## 2.12 Station Electrical Systems

The information in this section of the reference ABWR DCD, including all subsections, figures and tables, is incorporated by reference with the following departures.

STD DEP T1 2.12-1 (Tables 2.12.1, 2.12.12, 2.12.14 and 2.12.15)

STD DEP T1 2.12-2 (Figure 2.12.15)

Figure 2.12.15 Instrument and Control Power Supply

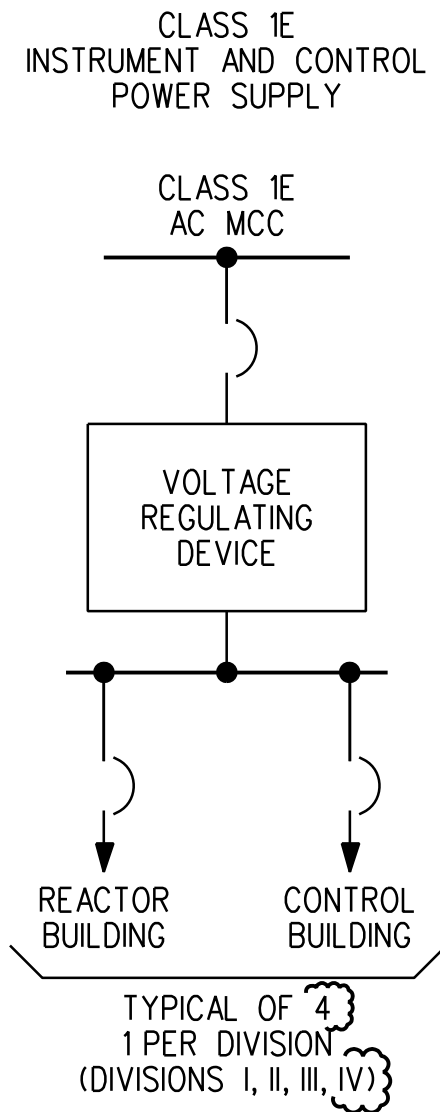
STD DEP T1 2.12-2

*The Class 1E Instrument and Control Power Supply consists of ~~three~~ four divisions (Division I, II, ~~and III,~~ and IV) of interruptible power supplies with their respective distribution panels. Each Class 1E power supply provides interruptible, regulated AC power to Class 1E circuits which do not require continuity of power during a loss of preferred power (LOPP).*
